REQUEST FOR AMENDMENT
SALEM GENERATING STATION
UNIT NOS. 1 AND 2
FACILITY OPERATING LICENSE NOS. DPR-70 AND DPR-75
DOCKET NOS. 50-272 AND 50-311

LCR 88-10

PROPOSED LICENSE CHANGE
SALEM GENERATING STATION
UNIT NOS. 1 AND 2
FACILITY OPERATING LICENSE NOS. DPR-70 AND DPR-75
DOCKET NOS. 50-272 AND 50-311

FIGURE 1

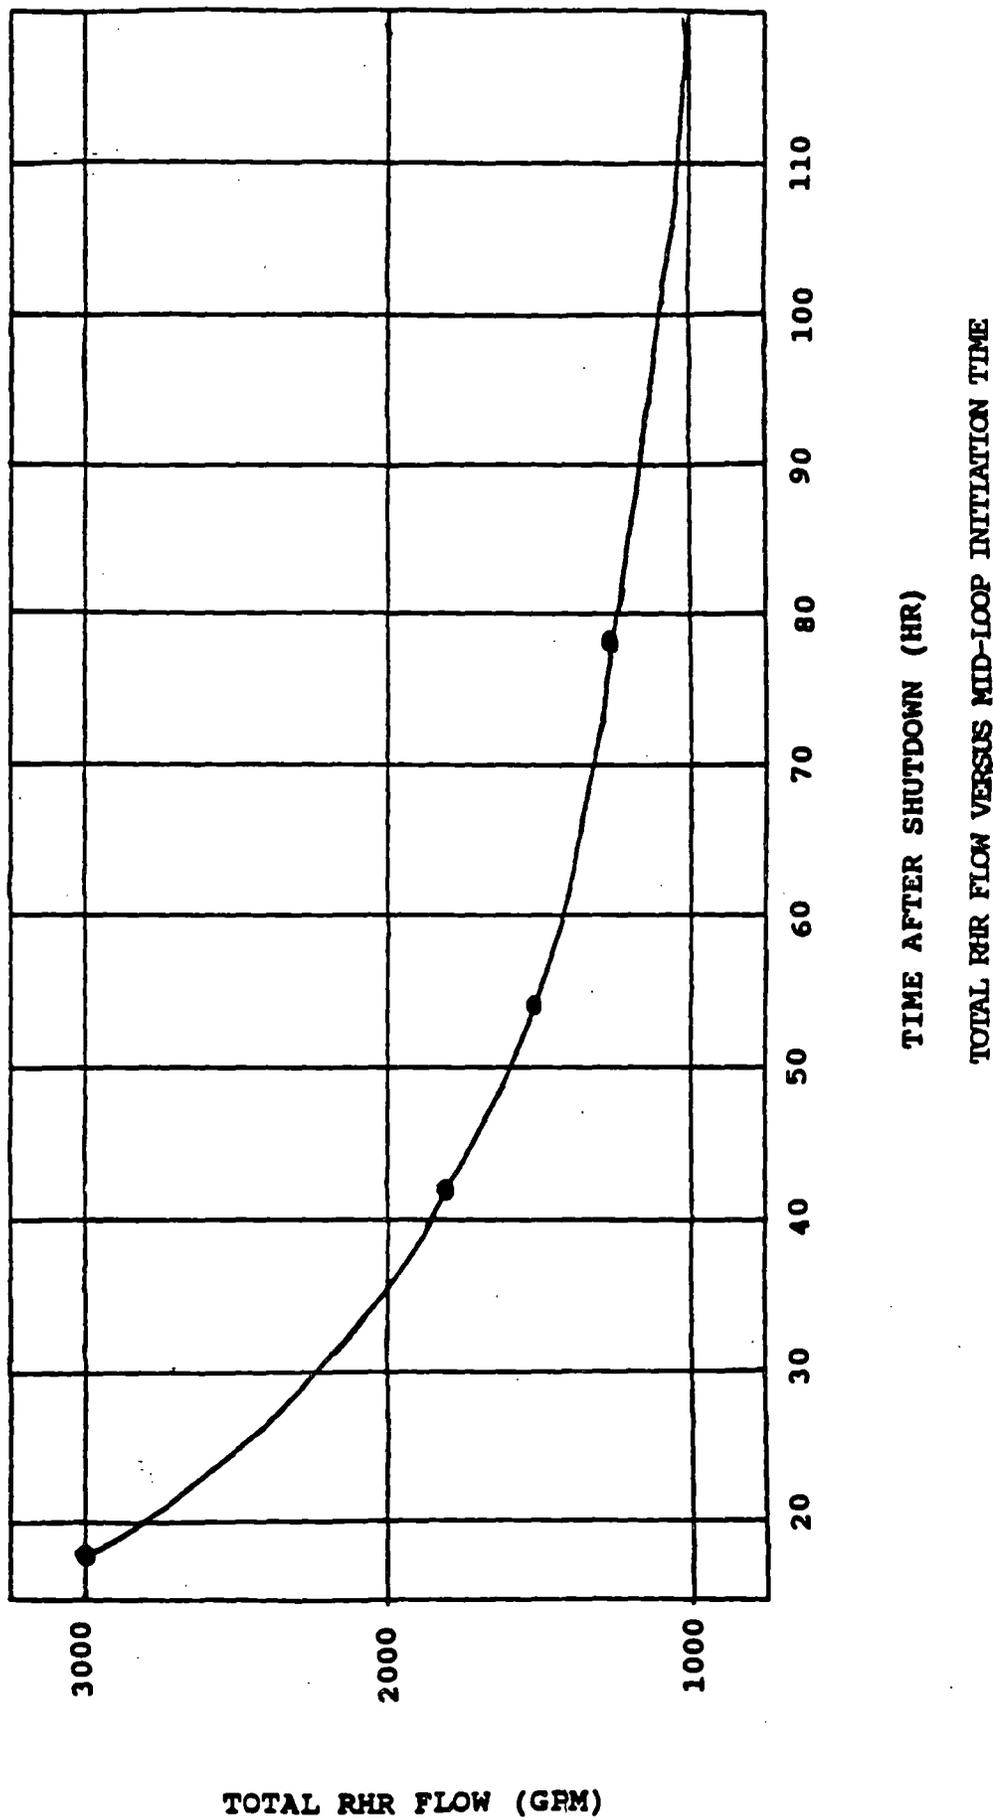
Table 1 (attached, excerpt from attachment 5 page 54) indicates the required RHR flow rate for specified periods of time after shutdown. Mid-loop operation is not implemented at Salem until at least 72 hours after shutdown (by procedure). Adequate decay heat removal can be accomplished with <1500 gpm RHR flow at this time. The required flow rate decreases further with increased time after shutdown. This is graphically depicted in Figure 1 (attached, excerpt from attachment 5 page 56).

FIGURE 2

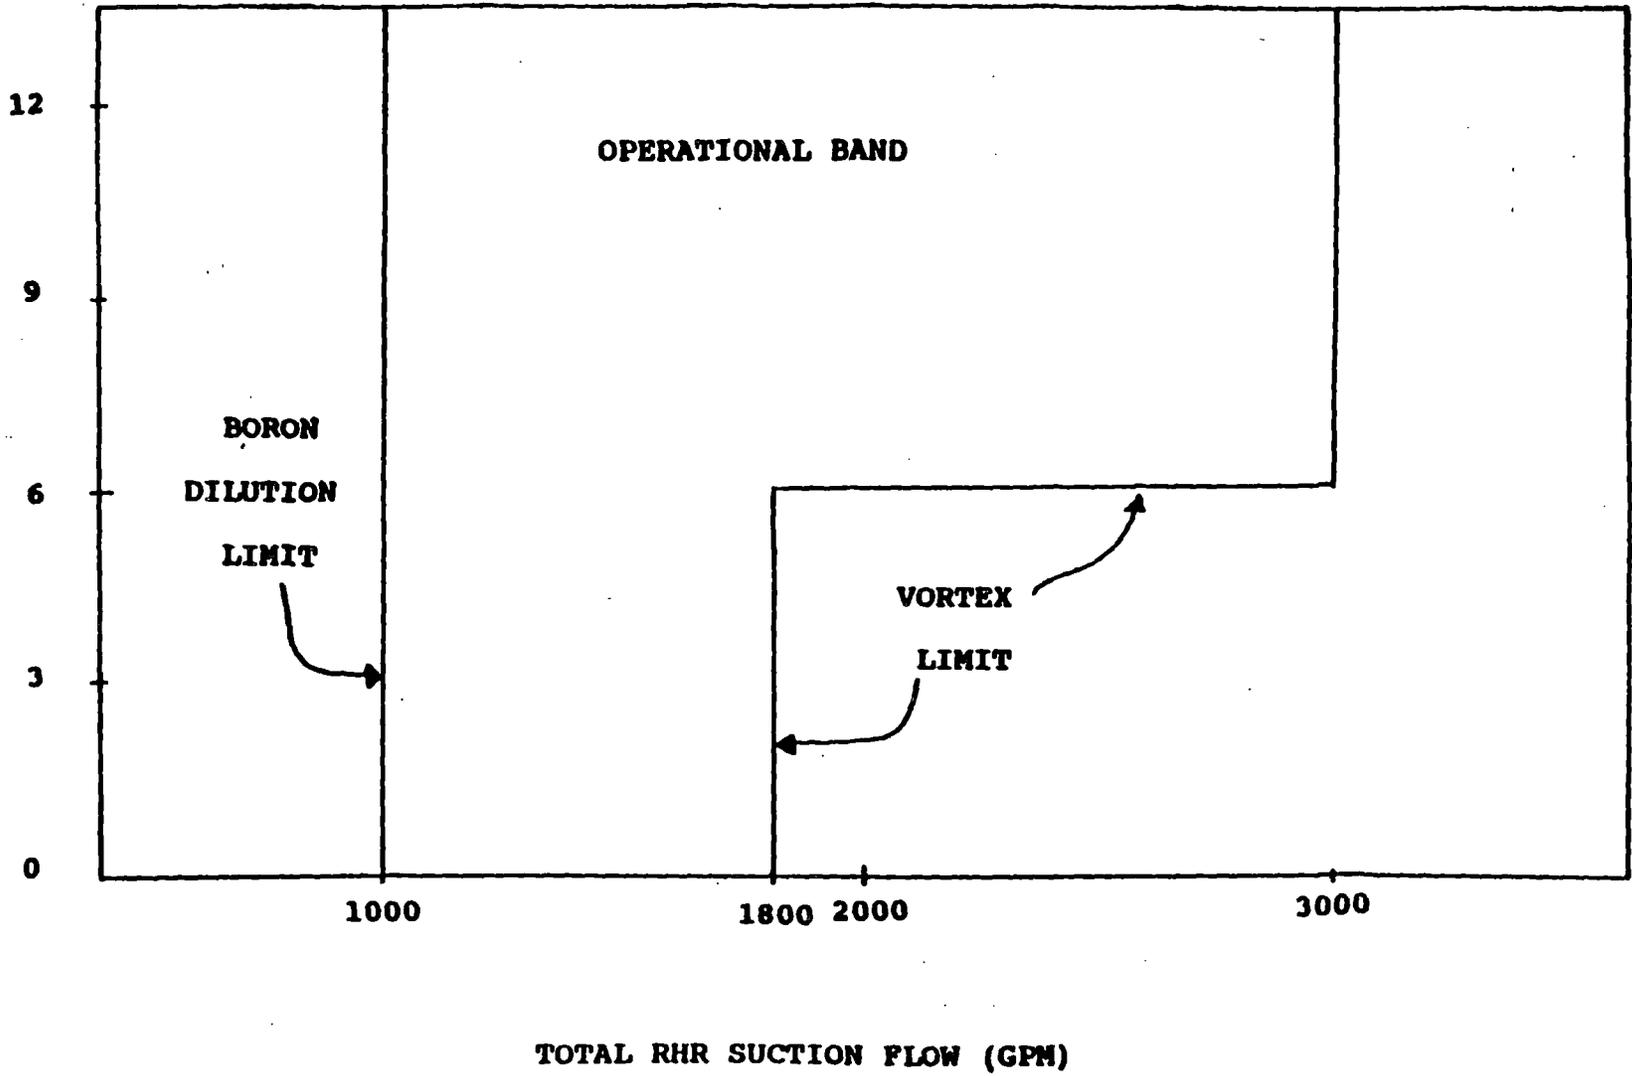
Figure 2 (attached, excerpt from attachment 5 page 57) depicts limitations on RHR flow rate for various RCS hot leg water levels. The data reveals that RHR flow rates should be maintained between 1000 and 1800 gpm when RCS hot leg water level is < 6 inches above centerline. RHR flow rates can be extended from a maximum of 1800 gpm to 3000 gpm, when RCS hot leg water level is > 6 inches above centerline. Figures 1 and 2 show that required RHR flow rates vary based on RCS water level and the time after shutdown. More importantly, the present Technical Specification minimum flow rate (3000 gpm) exceeds the maximum flow rate specified for vortexing concerns.
